Technical Service Bulletin: tsb100929

Released Date: 29-Apr-2010

New Water Outlet Connection

Figure1 - New Part Number 5261014 and Figure 2 - Old Part Number 3943300

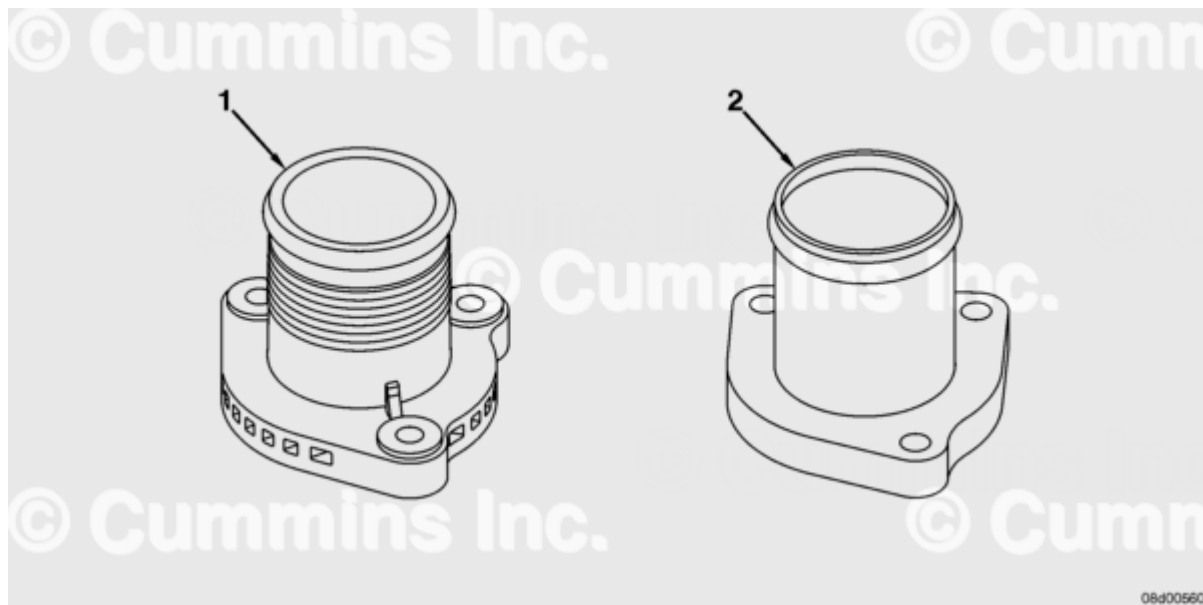
This Technical Service Bulletin announces the introduction of a new water outlet connection, Part Number 5261014, manufactured from Polyamide HTN51, to replace the present, water outlet connection Part Number 3943300, manufactured from metal.

The new design incorporates the addition of ribs and compression limiters to strengthen the part and distribute stress loads. There is no change to the location interface or fastening process.

Outside Diameter		Inside Diameter		Pipe Wall Thickness	
Old	New	Old	New	Old	New
44.45 mm	44.45 mm	41.15 mm	38.45 mm	1.15 mm	3.0 mm
